Specification Gaps and Improvement of MDC/ MDIO Interface for Automotive Applications

Rubén Pérez-Aranda
David Ortiz
Luis Manuel Torres

Figure 22–19—MDIO sourced by PHY

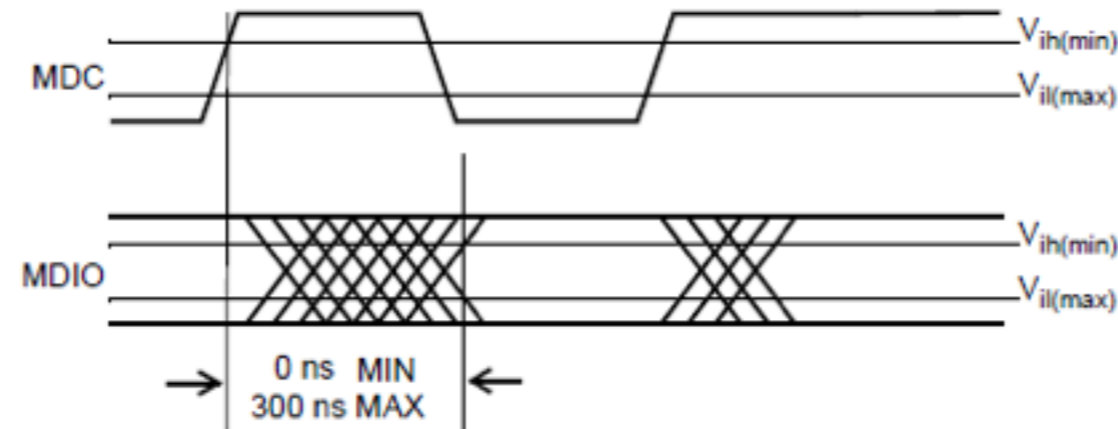
When the MDIO signal is sourced by the PHY, it is sampled by the STA synchronously with respect to the rising edge of MDC. The clock to output delay from the PHY, as measured at the MII connector, shall be a minimum of 0 ns, and a maximum of 300 ns, as shown in Figure 22–19.

- Change clock to output delay from the PHY maximum from 300 ns to 60 ns (reduction by a factor of 5)
- That means a change in subclause 22.8.3.2 MII signal timing constraints item ST6

Figure 45–4—MDIO sourced by MMD

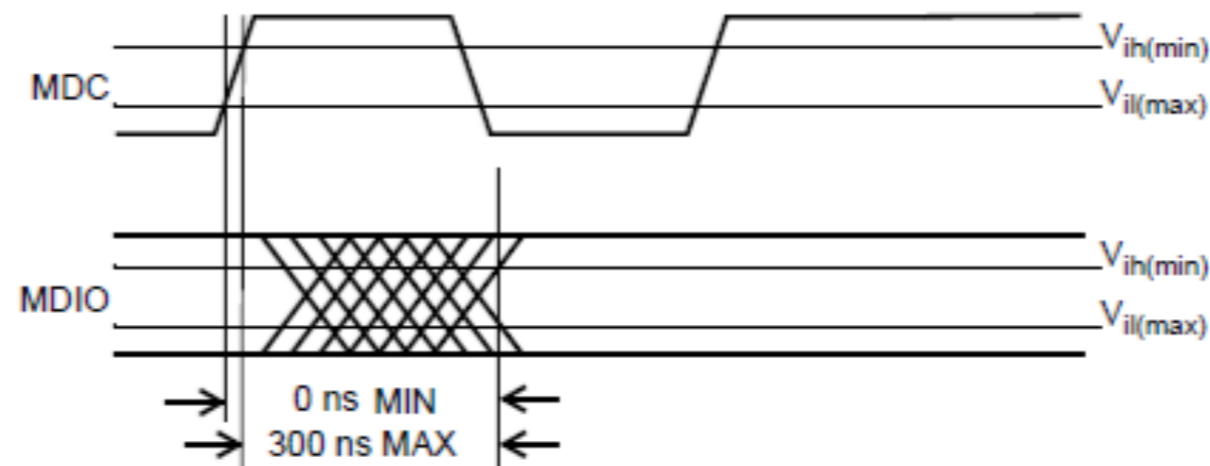
When the MDIO signal is sourced by the MMD, it is sampled by the STA synchronously with respect to the beginning of the rising edge of MDC. The clock to output delay from the MMD, as measured at the STA, shall be a minimum of 0 ns, and a maximum of 300 ns, as shown in Figure 45–4.

- Change the maximum clock to output delay from the MMD from 300 ns to 60 ns (reduction by a factor of 5)
- That means a change in subclause 45.5.3.20 Signal timing characteristics items ST2, ST3 and ST4.
- Minimum setup and hold time when MDIO sourced by STA does not change
